Access Compliance Report

Public Rights-of-Way

(Curb Ramps)

Intersection ID: 3193	Main Street: HIGHCROFT_LN	Cross Street: STONEYKIRK_LN	Location: SW
ADA ID: 6B70948D1091	Ramp Type: Perp	Initial Pass/Fail: Pass	Overall Compliance: No
Severity Score: 10			
Codes/Mitigation Info/Possible Solution		Field Measurements/Component Compliance

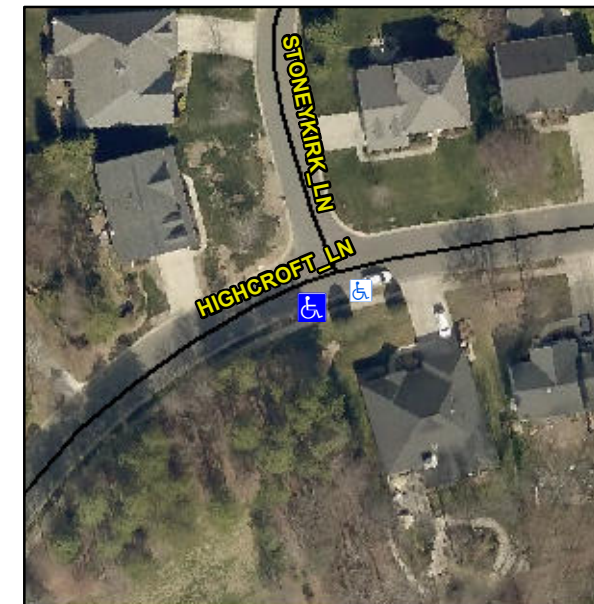
Not Found, R305

Compliance	Description	Data	Compliance	Description	Data
N/A	Ramp Length (in)	48.0	Yes	Ramp Slope (%)	5.1
Yes	Ramp Width (in)	48.0	Yes	Ramp XSlope (%)	1.2
N/A	Flare Type LT	Sloped	N/A	Flare Type RT	N/A
N/A	Flare Slope LT (%)	1.3	N/A	Flare Slope RT (%)	4.1
N/A	Flare Traversable LT?	No	N/A	Flare Traversable RT?	No
Yes	Landing Length (in)	49.0	No	DWS Provided?	No
Yes	Landing Width (in)	48.0	N/A	DWS Contrast?	No
Yes	Landing Slope (%)	0.7	N/A	DWS Length (in)	N/A
Yes	Landing X Slope (%)	0.1	N/A	DWS Full Width?	No
N/A	Landing Curb? (Y/N)	No	N/A	DWS Offset (in)	N/A
N/A	Shared Landing?	No			
Yes	Gutter Ponding?	No	Yes	Gutter Slope (%)	4.4
Yes	Gutter Lip Ht (in)	0.0	Yes	Gutter X Slope (%)	1.7
N/A	Painted X Walk1?	No	N/A	Painted X Walk2?	N/A
	X Walk 1 Direction	To N		X Walk 2 Direction	N/A
N/A	X Walk 1 Width (in)	N/A	N/A	X Walk 2 Width (in)	N/A
	X Walk 1 Slope (%)	3.8		X Walk 2 Slope (%)	N/A
	X Walk 1 X Slope (%)	1.6		X Walk 2 X Slope (%)	N/A

N/A	Ramp inside XWalk1?	N/A	N/A	Ramp inside XWalk2?	N/A
	Road Slope (%)	N/A	N/A	Clear Space?	Yes
	Road X Slope (%)	N/A	N/A	Clear Space to XWalk (in)	N/A
Yes	Any Obstructions?	No	Yes	Storm Grate/Utility Hazard?	No
	Obstruction Type			Storm Grate/Utility Type	
		N/A			N/A
			Yes	Surface Condition? (G/P)	Good

Remove & Replace Entire Ramp.
